LiDAR Quality Assessment Report

UT_GSLTooeele_2011

This data set created using LiDAR points collected from airborne surveys completed on October 18, 2012 and covers approximately 106 square miles contained in the following county(s): Tooele County, Utah; Salt Lake County, Utah.

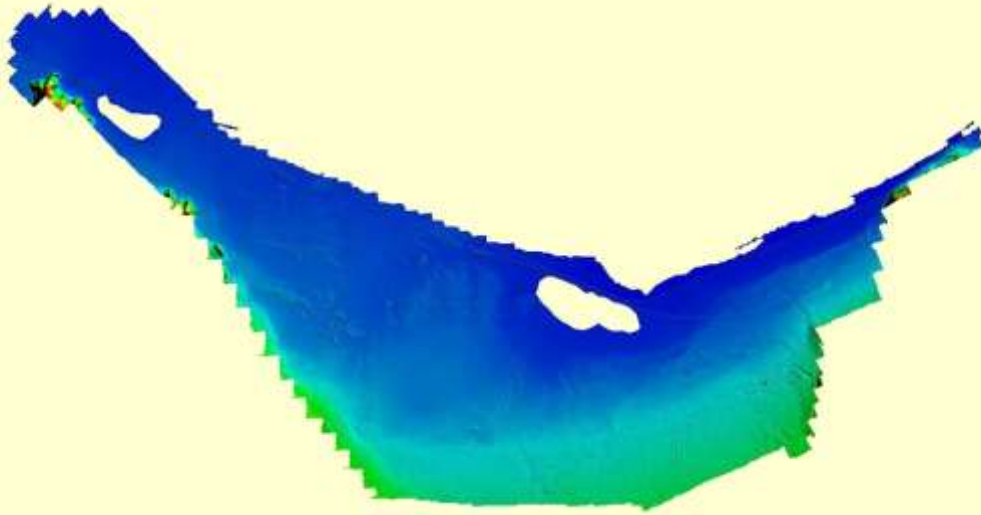
DEM Tiles do not perfectly Conform to the Tiling Scheme in terms of quantity, i.e., 95 DEM Tiles out of a Tile Scheme of 98 Tiles. However these missing tiles are outside the project extent and do not affect the final mosaicked DEM. Missing Tiles are: 25, 39, and 44.

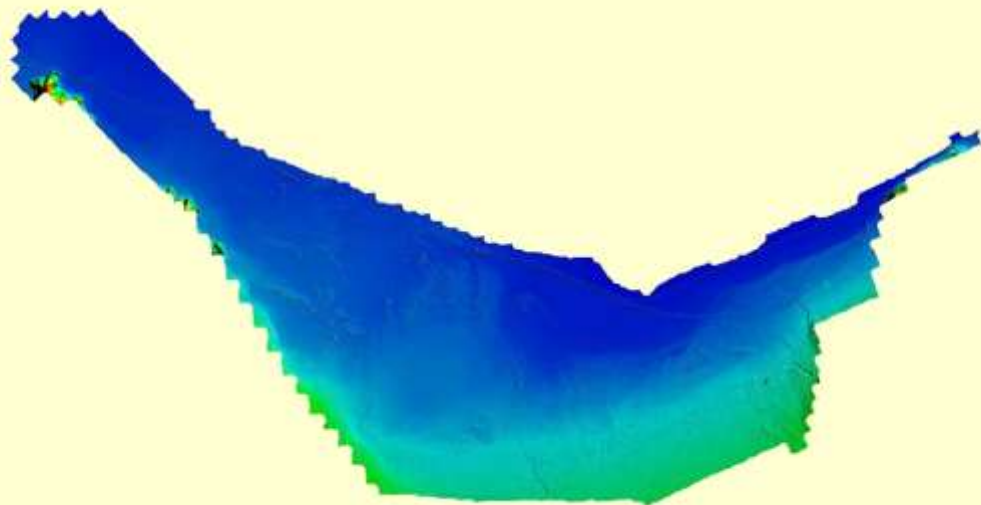
Mosaic of original DEM tiles above, many water areas gridded as "no data".

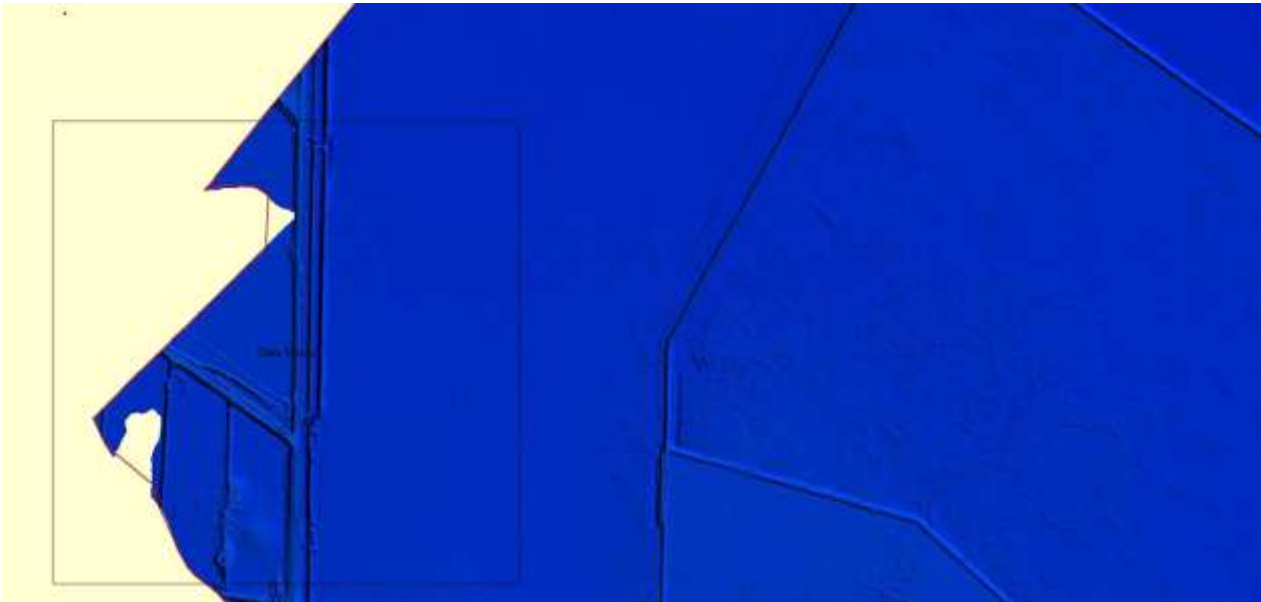
In order to make the DEM usable in the 1/9th NED the Water needed to have a value, A final mosaic was created by the USGS that coded each interior lake with a constant (flat) value of the lowest bordering pixel. The project boundary for the project was also determined to be the maximum swath extents and was buffered in by 100 Meters and cut out on the southern portion to ensure there were no gaps in the data due to the flight lines. The final product sent to the NED should be free of data voids and have adequate point density for gridded areas included in the final mosaicked DEM. This also has an accompanying DEM Project Footprint and is 96.05 SqMi.

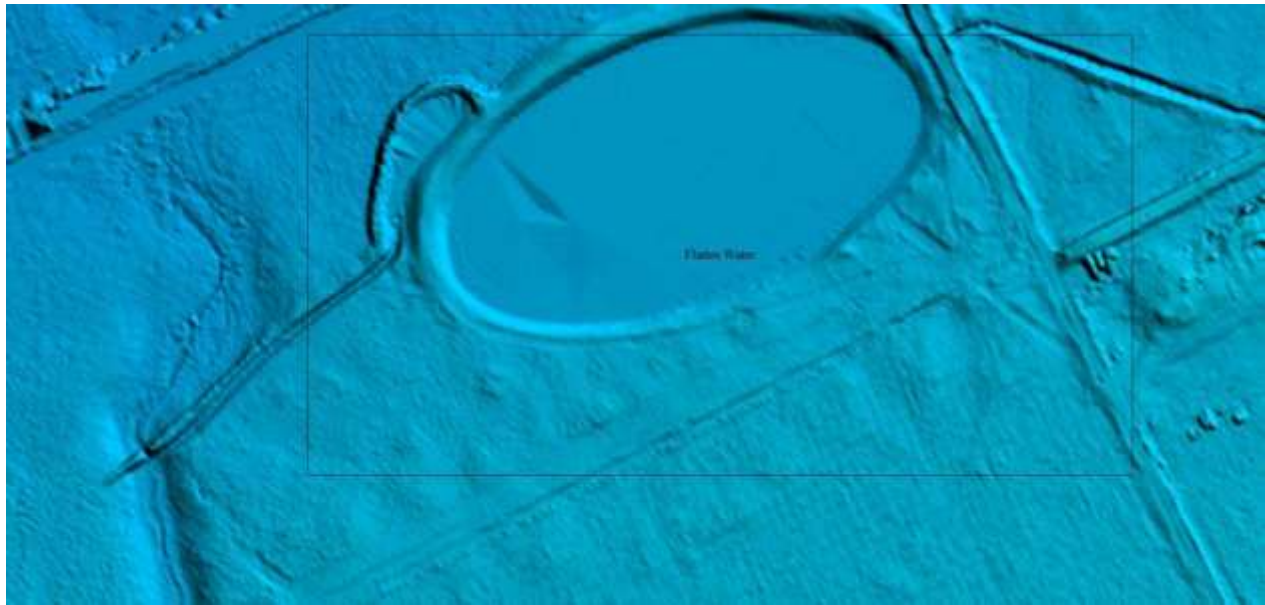
The Project extent and gridded data did not match, in order to reduce edge artifacts and data voids the final DEM was buffered in by 100 Meters.

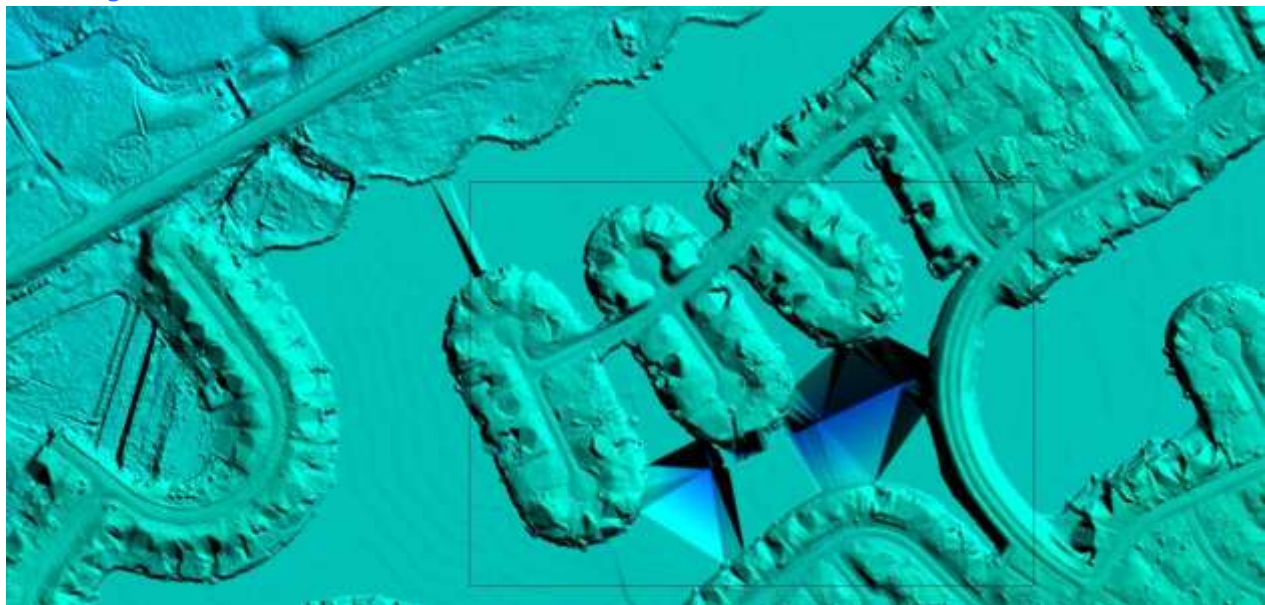
A few instances of distinct waterbodies larger than 2 Acres could be flattened.

There was a single instance of a large pit/sink in the water area pictured above.
